PR/0730/22

Record of Executive Business and Chief Executive's Order

Reg. Reference: SD21A/0321 **Application Date:** 22-Nov-2021
Submission Type: Clarification of **Registration Date:** 11-May-2022
Additional
Information

Proposed Development: Construction of 2 storey, detached house (single family dwelling on a corner/side garden site); new boundary walls to replace existing with 2 new pedestrian entrance gateways; associated site works, landscaping and connections to public services.

Roads Related Additional Information Requested by SDCC:

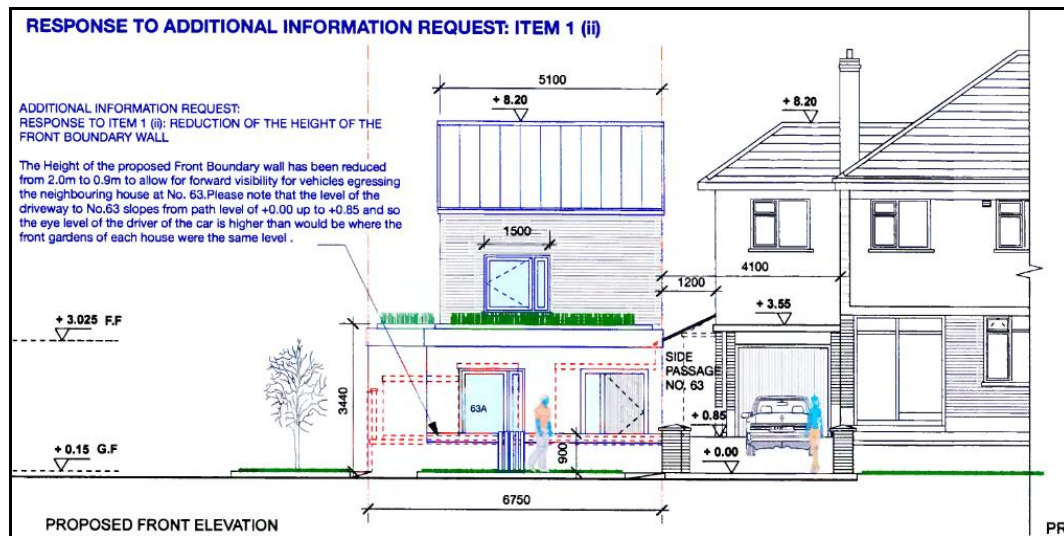
*1 (i). The applicant has not fulfilled the request for additional information by failing to demonstrate that there is “enough room to provide for a 6 metres long driveway for a car to park with a vehicular entrance with a maximum width of 3.5m.” Section 4 of the **SDCC House Extension Design Guide** sets out a minimum driveway length of **6m**.*

*The applicant has made a case for having no on-curtilage parking and this was considered by the Roads Department. However, with reference to **Section 11.4.2** of the **SDCC County Development Plan 2016-2022**, in order to be considered for car free housing, the site must “have convenient access to high frequency public transport services and / or are located*

- *Section 11.4.2 of the SDCC County Development Plan 2016-2022 states that in order to be considered for lower parking rates in Zone 2 a site must be **within 400m of a high quality bus service.***
- *Section 11.4.2 of the SDCC County Development Plan 2016-2022 states that A high frequency route is where buses operate with a minimum **10 minute frequency at peak times and a 20 minute off-peak frequency.***
- *250m from the proposed site is Willbrook Road Stop 2946 which is only serviced by the **No 61 bus** which stops approx. every **1hr.***
- *550m from the proposed site is Willbrook Road, Stop 1330 on Grange Road which would be considered a high quality route with numerous bus services running every **10 mins** approx.*
- *The nearest high quality bus service is therefore beyond the threshold of 400m and so the site cannot be considered for car-free housing.*

The applicant has also submitted 2 possible options for locations of off-curtilage parking but they are in areas outside the ownership of the applicant so cannot be considered as they would set an undesirable precedent for further similar parking arrangements in the area.

Response to Item 1(f)

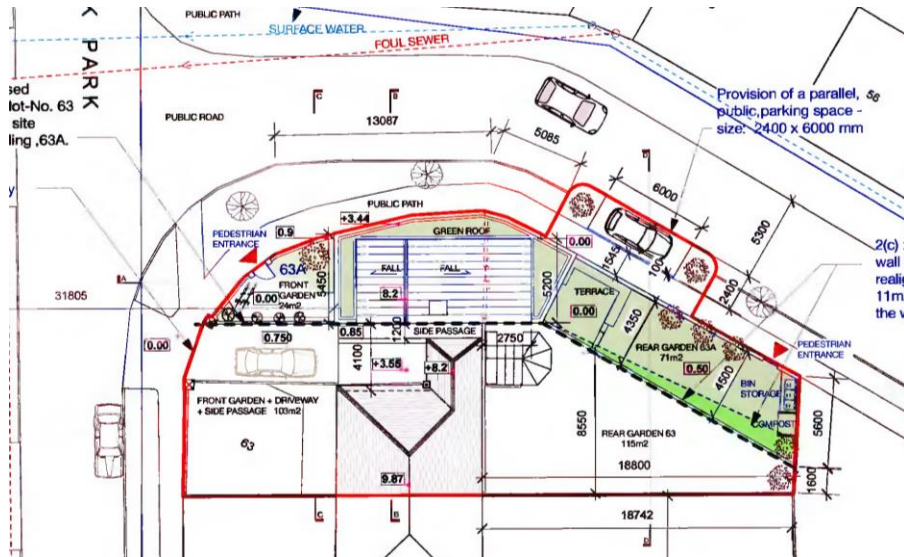
1(a) of the request. Therefore the revised red line boundary suggesting the extent of ownership for the subject site taking in part of the public realm is not considered to be correct.

Considering the recommendation of the Roads Section to refuse permission the Planning Authority is not satisfied that the applicant has satisfactorily addressed the car parking issue and the proposal would endanger public safety by reason of a traffic hazard.

The Planning Authority considers that the use of the parking space could be unallocated by way of condition and the non compliance with DMURS. The Roads report states that the proposed on street car parking at this location may cause a traffic hazard. In addition, it is considered that the absence of on site car parking is indicative of overdevelopment and is contrary to the pattern of development in this established lower density area.

The applicant has considered the possibility of a shared parking area with the existing house no. 63 but given the difference in ground level between the properties and the sloped nature of the existing driveway for No. 63, it is not considered a feasible proposal. The applicant hopes to create a level approach to the proposed house 63A from the public path and car parking space to allow ease of access to the house for her elderly mother who has mobility issues.
